# **KEMPS CREEK ESTATE – SSD-9522 MOD 3**

Amended Development Report

Prepared for  
**FRASERS PROPERTY INDUSTRIAL &  
ALTIS PROPERTY PARTNERS**  
29 August 2022

Figure 21 Proposed amendment to SSD-9522 MOD 3 – Landscape Plan

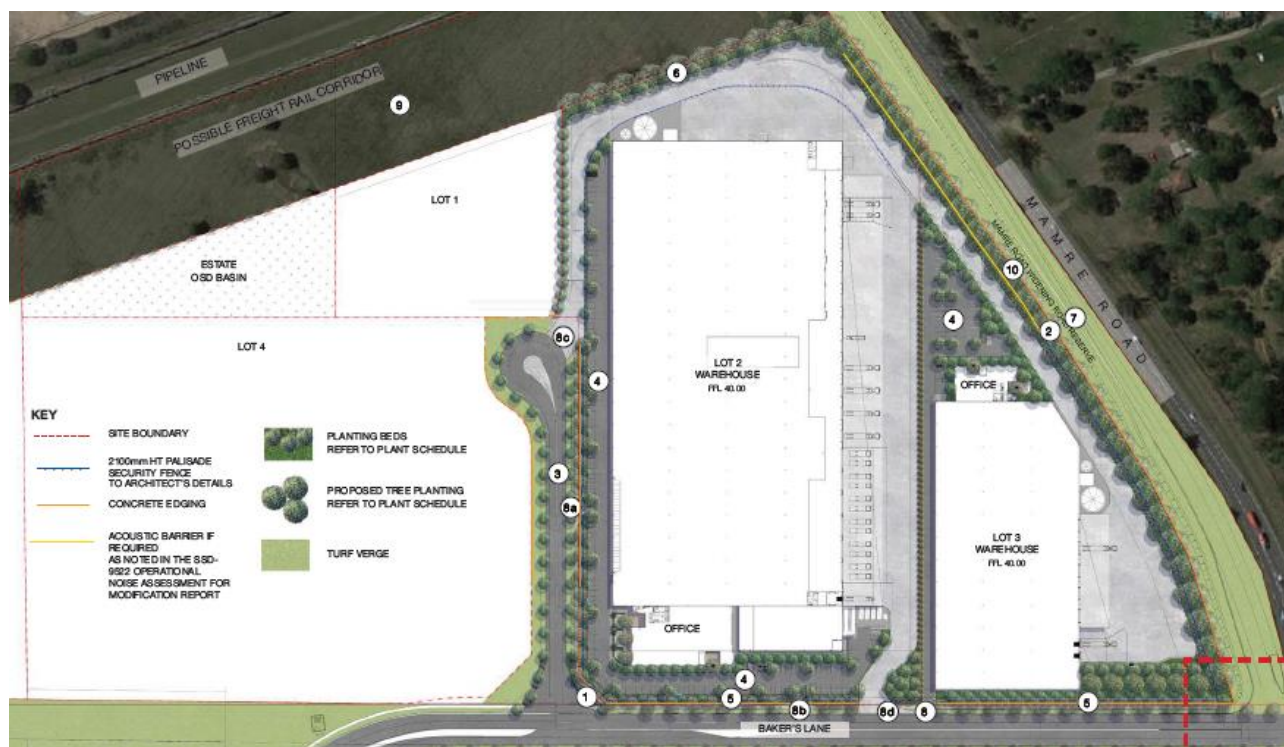
Habitat8 have prepared an updated Landscape Plan in response to the updated site layout plan. The Landscape Plan (refer **Figure 21**) maintains the same landscape principles and revegetation strategy as approved under SSD-9522.

The reconfiguration of Lots 1-4 has resulted in a reduction in the overall landscape area and tree canopy cover, due to the withdrawal of built form on Lots 1 and 4. The landscape outcome in MOD 3 for the remaining areas of the site in Lots 2 and 3 has improved with additional landscape and tree canopy areas proposed in comparison to the original SSD-9522 consent. The MOD 3 Landscape Plan increases the tree canopy cover on Lots 2 and 3 by 2,348m<sup>2</sup> (from 17,154m<sup>2</sup> to 19,502m<sup>2</sup>) and an increased landscape area of 374m<sup>2</sup> (from 9,846m<sup>2</sup> to 10,220m<sup>2</sup>).
